OUR REF: 21224 - S4.55

RE: SECTION 4.55 MODIFICATION FOR DEVELOPMENT APPLICATION (DA NO. 2008/1216) NO. 1184-1186 PITTWATER ROAD, NARRABEEN

Proposed
Source: Bonus and Associates
Figure 2: Approved and Proposed Basement Floor Plan

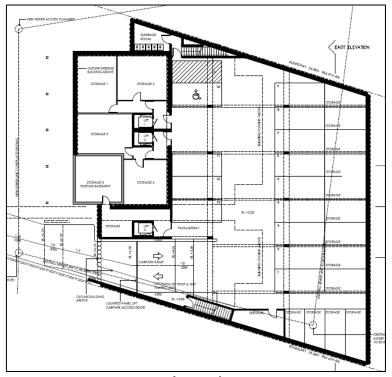
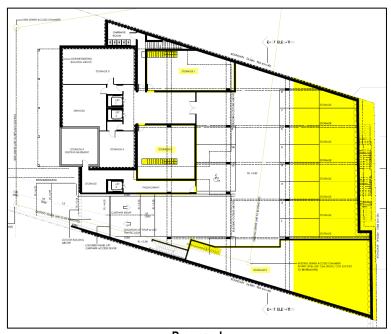
Basement Floor Level

The proposed modifications to the approved Basement Floor Level include:

- Increase excavation by approximately 861m³ toward the eastern boundary to accommodate additional storage;
- Construction of a new concrete contiguous pile to accommodate a new seawall at the eastern extent of the site:
- Relocation of car parking and reduction of two car parking spaces resulting in 11 car parking spaces in the basement; and
- Provision of internal stairs from storage areas to Units 1, 3 and 5 located on the Ground Floor Level (see Figure 2 on the following page).

Figure 3: Approved and Proposed Ground Floor Plan

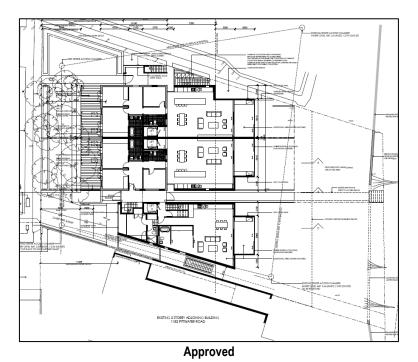
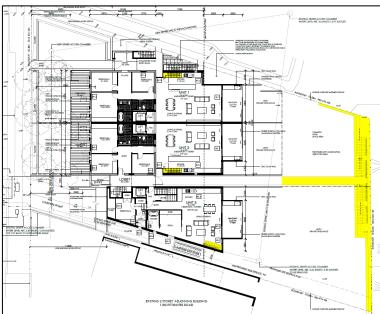
Ground Floor Level

The proposed modifications to the approved Ground Floor Level include:

- Construction of a new seawall and stairs at the eastern extent of the site which will be accessible from Narrabeen Beach; and
- Provision of internal stairs to the basement floor level from Units 1, 3 and 5 (see Figure 3).

Figure 4: Approved and Proposed Sections

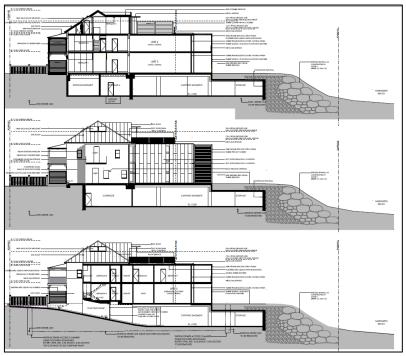
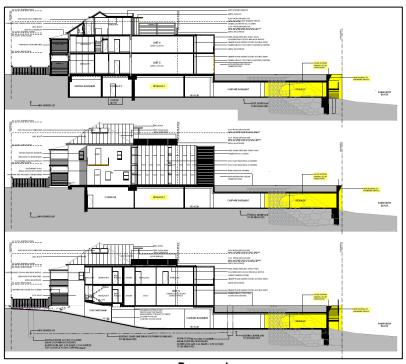
The proposed works are required to remove the existing damaged sea wall and provide a new concrete contiguous pile seawall which is considered to improve the relationship of the proposal with the adjoining developments. The proposed seawall will improve continuity of coastal protection measures in the locality and may reduce coastal risk to adjoining properties (see **Figure 4** on the following page).
